Alexandria Toyota
3750 Jefferson Davis Highway

Text Amendment #2008-0006 (A)

DSUP Amendment #2007-0034 (B)

Planning Commission
June 3, 2008

Figure 7 Staff Recommended Landscape Along Commonwealth Avenue

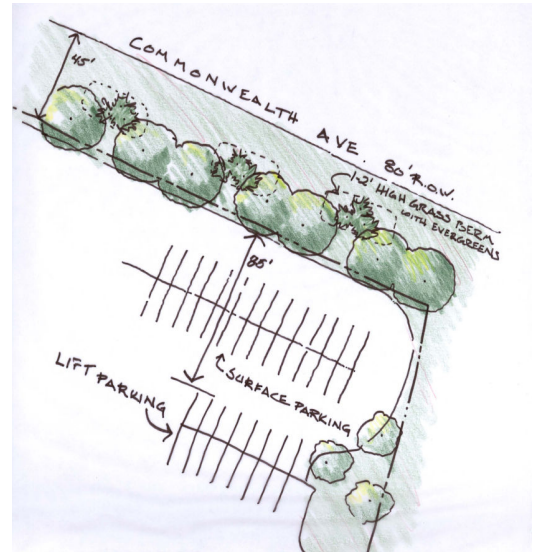
of Commonwealth. Also, staff is recommending that the applicant install new landscaping along Commonwealth Avenue to screen the proposed development as generally depicted in Attachment #1. In addition to these enhancements, per the previous approval, (DSUP #2002-0050, cond. #58) the applicant has provided to the City \$50,000 for landscape improvements along Four Mile Run trail and Commonwealth Avenue. The improvements consist of street trees (30 feet on center) and irrigation for the plantings. At present, Potomac Yard development is completing sewer line upgrades along Commonwealth. Once those improvements are completed, the City will install the landscape.

6. **Condition added by staff:** The applicant shall provide a landscape design along the entire Commonwealth frontage as generally depicted in Attachment #1 and shall be designed and installed and to the satisfaction of the Directors of P&Z and RP&CA. The plan shall include:
